RE: 3731 NM-528 NW
Grading and Drainage Plan
Engineer's Stamp Date: N/A
Hydrology File: A14D003E1
Case # HYDR-2025-00381

Based upon the information provided in your submittal received 03/30/2026, the Grading and Drainage Plan **is not approved** for Grading Permit and Building Permit. The following comments need to be addressed for approval of the above referenced project.

PROJECT NAME
**DON CHALMERS FORD
 PARKING ADDITION**

OVERALL GRADING AND DRAINAGE PLAN

SHEET NO:
C1.02

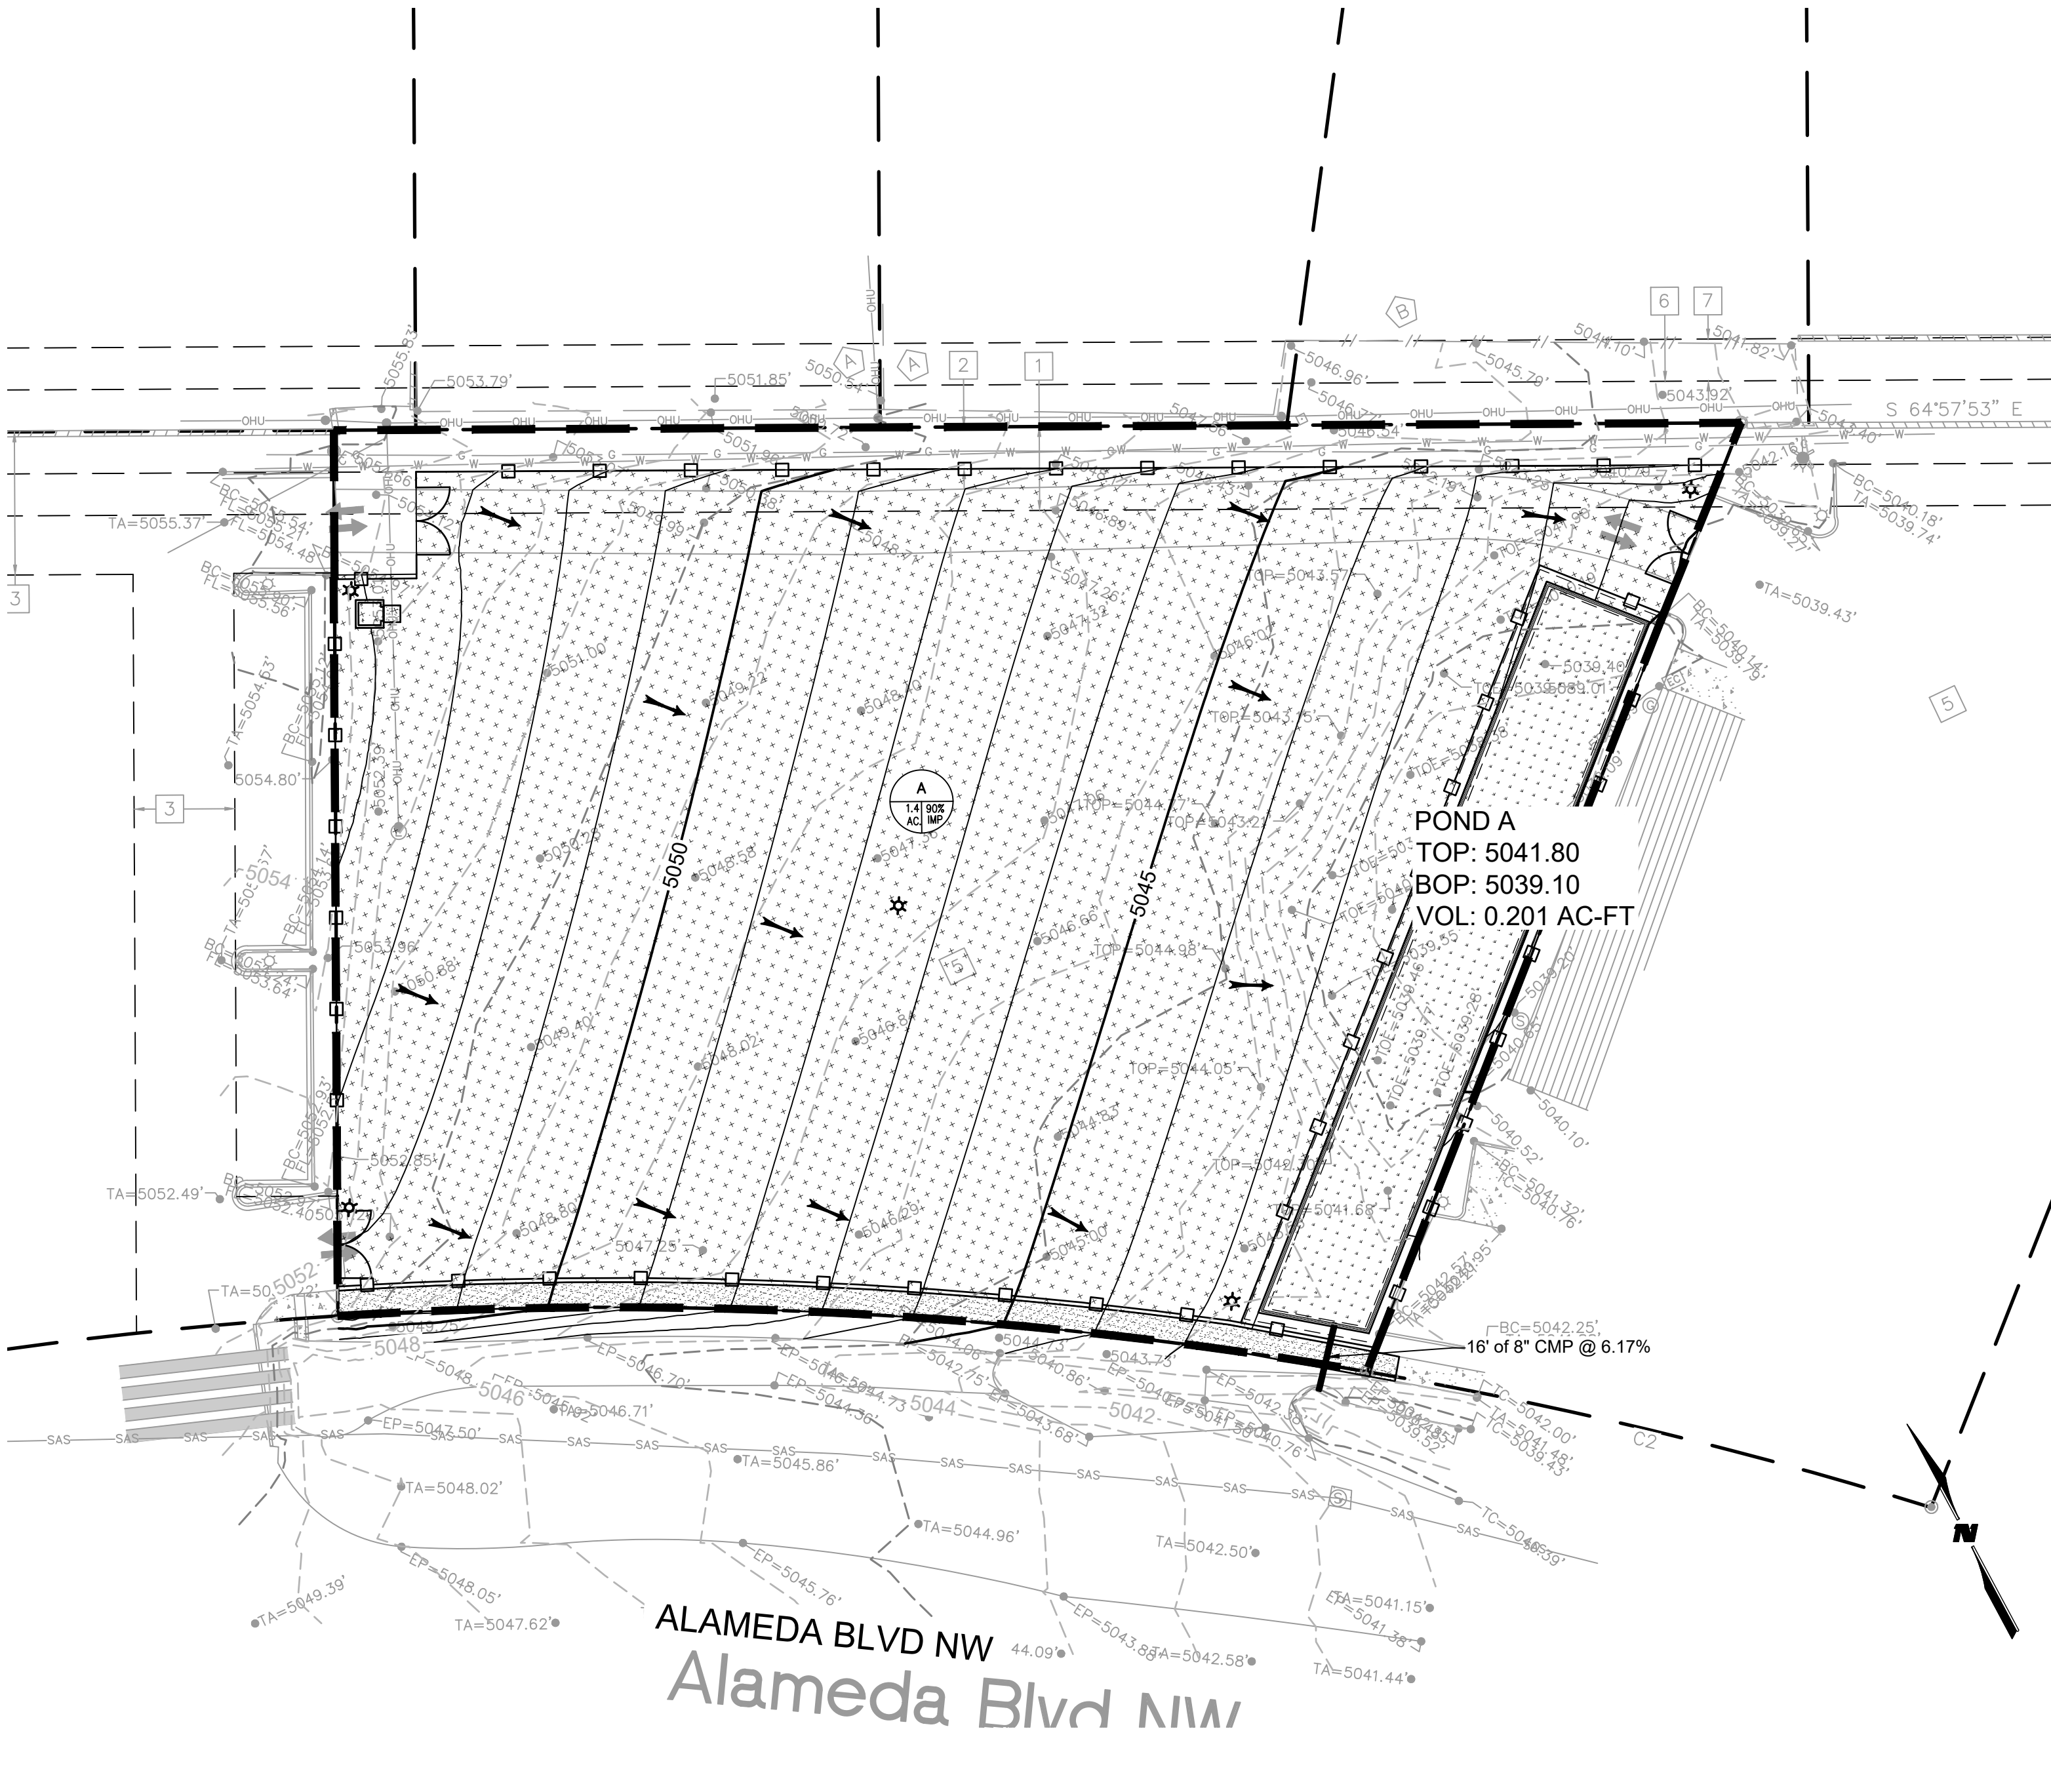
Reject and tell them to coordinate with DOT
